Request for Class II Permissive Change(C2PC)

FCC ID: VG8EM245AXX-P1

This is a C2PC application for which the previous grant was issued on 2010-07-15.

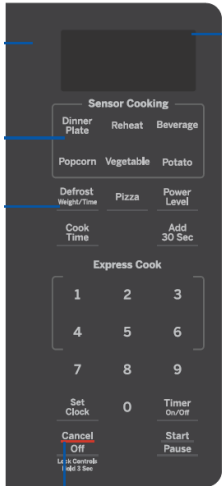
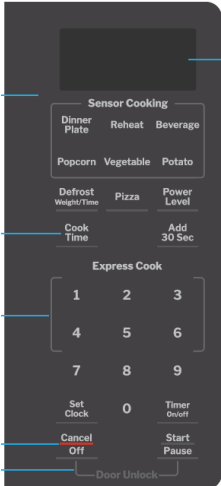
No.:	Original	New	Difference(s)
1			Keypad: Updated front keypad to accommodate child lock function (Child resistant oven door function).
2			Mother board: Modified the peripheral circuit (non-RF circuit) and some individual components and PCB layout. The magnetron and other circuit are exactly same as before.
